3/4.4 REACTOR COOLANT SYSTEM

3/4.4.1 RECIRCULATION SYSTEM

RECIRCULATION LOOPS - TWO LOOP OPERATION

INFO ONLY.
SEE PROPOSED
AMENDMENT 119
PLA-3141, 2/2/89

Figure 3.4.1.1.1-1
THERMAL POWER LIMITATIONS

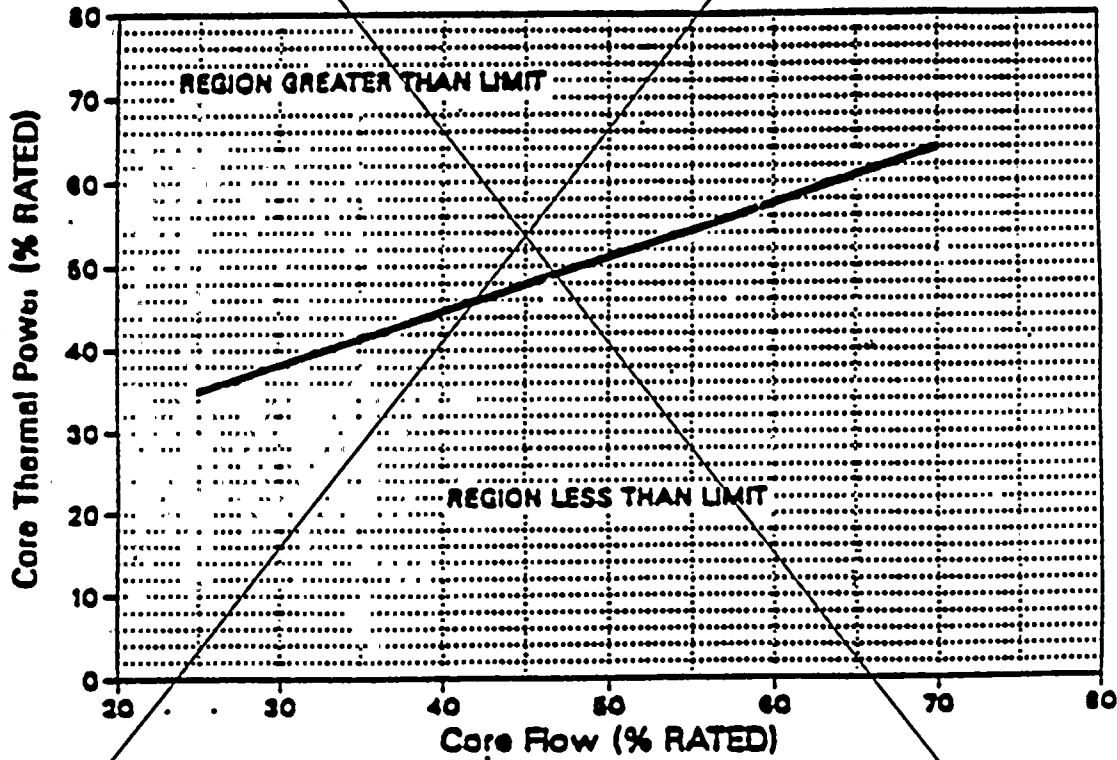
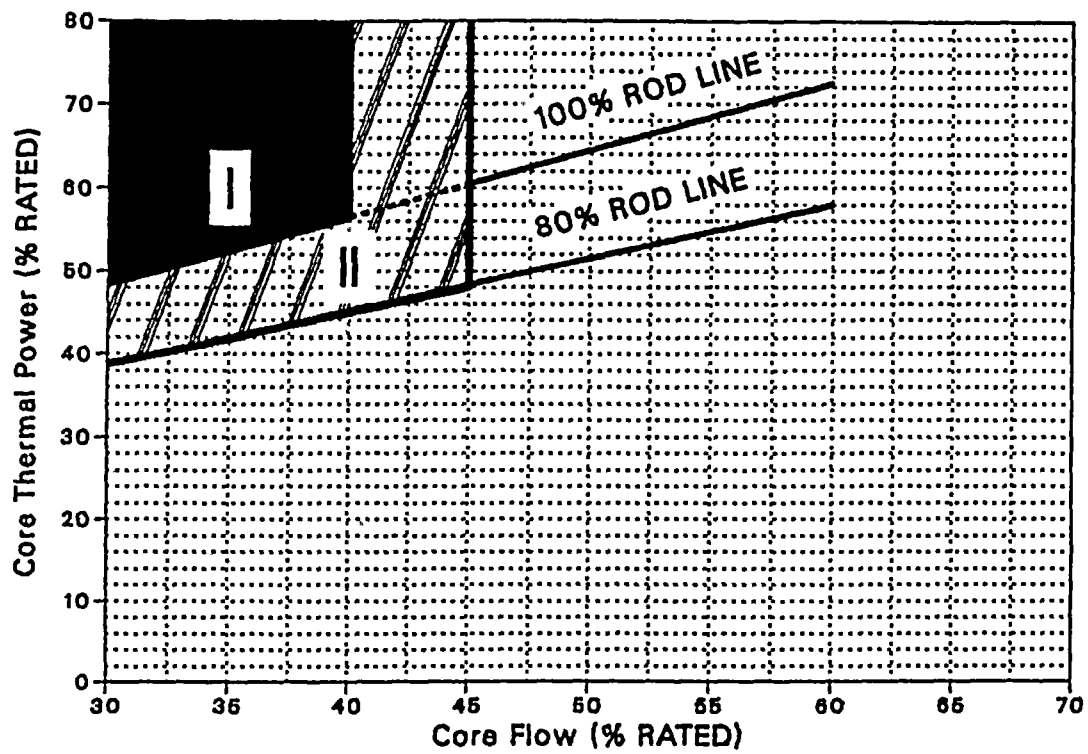
REPLACE WITH REVISED FIGURE 3.4.1.1.1-1

Figure 3.4.1.1.1-1
THERMAL POWER RESTRICTIONS

Specifications have been provided to prevent, detect, and mitigate core thermal hydraulic instability events. These specifications are prescribed in accordance with NRC Bulletin 88-07, Supplement 1, "Power Oscillations in Boiling Water Reactors (BWRs)," dated December 30, 1988. The boundaries of the regions in Figure 3.4.1.1.1-1 are determined using ANF decay ratio calculations and supported by Susquehanna SES stability testing.
